**12.7. TOWN ENTRY SIGNAGE CONSULTATION OUTCOMES****REPORT PURPOSE**

## 12.7 TOWN ENTRY SIGNAGE CONSULTATION OUTCOMES

The two design options for the signs were:

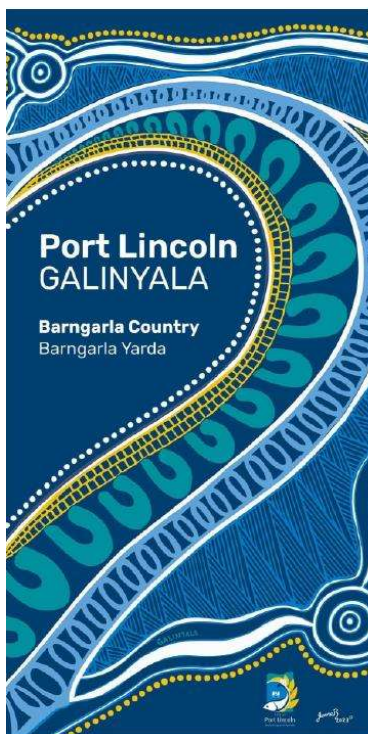
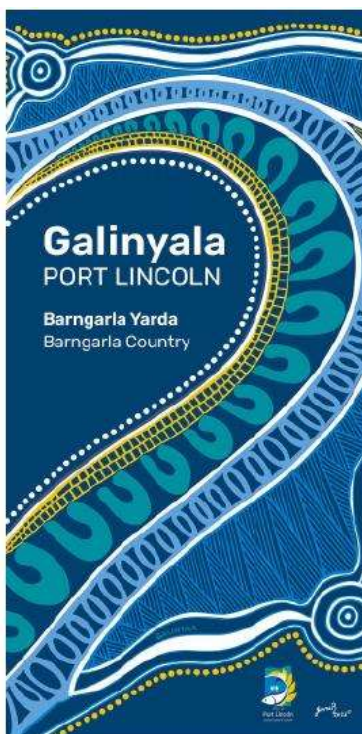
Suggestions were made about increased font sizes and capitalisation with concerns that the place names aren't prominent enough and ensuring that visitors see the name Port Lincoln first.

I love the art work. However in both options I feel the place names aren't prominent enough. A car travelling at speed only gets micro seconds to look at the sign and currently the eye is drawn to the art and not the place names.

I think the writing may be too small driving at 80km, especially the 3rd and 4th line.

Galinyala writing under Port Lincoln should be smaller. The letter sizes in both designs have Galinyala as bigger and Port Lincoln smaller in comparison.

The design is very good. My reason for choosing option #1 is the town name should be in English first with the Indigenous name second. Remember that the people looking at this sign are going to be motoring at 80 or 60 kph and have limited time to absorb the main message on any sign, so it is critical that they know that "Port Lincoln" welcomes them to town.

Regarding the feedback about font size and visibility, the sign concept has been prepared with reference to DIT Road Sign Guidelines 2.3.2:

*Entry Point signs and will be 1.4 metres wide and 3 metres high.*

The approximate size of the sign in relation to a person (5'6") is shown below. As such the size of the main font will be 120 mm.

Officers will work with the graphic designer to maximise the font size of Port Lincoln however it is not proposed to capitalise the wording.
